WORKSHOP AGENDA

Planning Commission

December 12, 2023 @ 5:30 PM

For the December 26, 2023 Regular Meeting @ 6:00 PM

WALDRON ROAD ENLARGEMENT

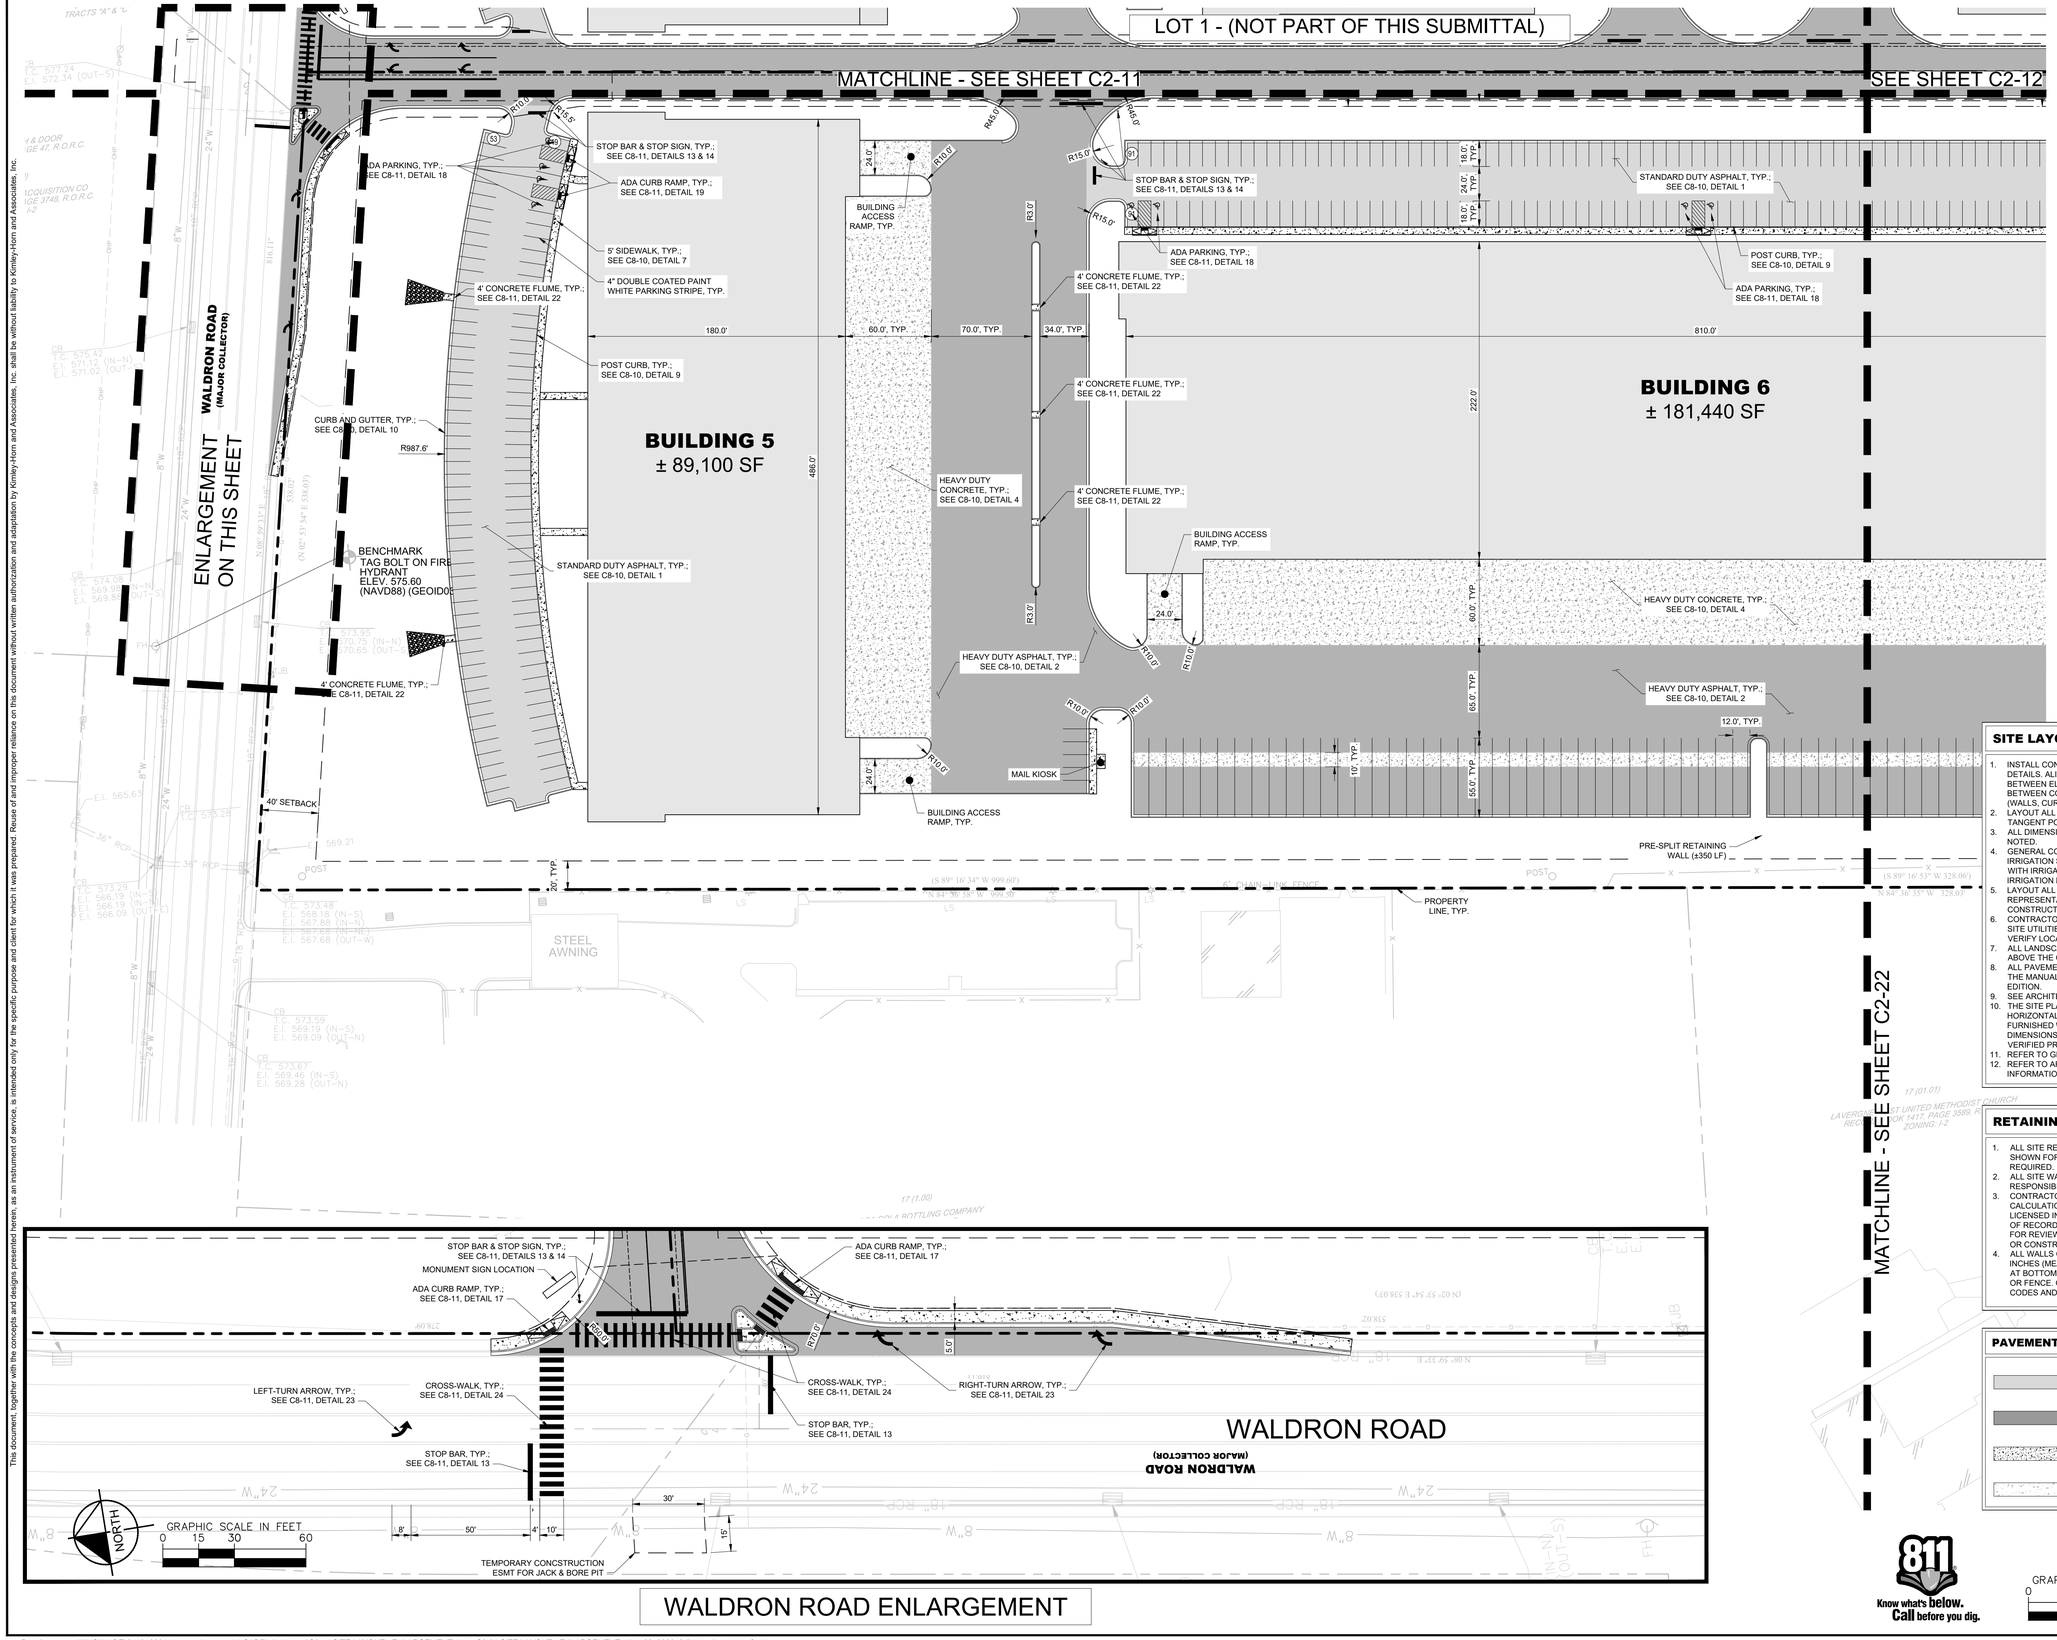
3. Provide sufficient layout information to stake parking, drives, utilities, etc. from the buildings or the property line.
4. Provide dimensions (lane widths) for driveway onto Waldron Road (this applies to sheet C2-21 of Lot 2)
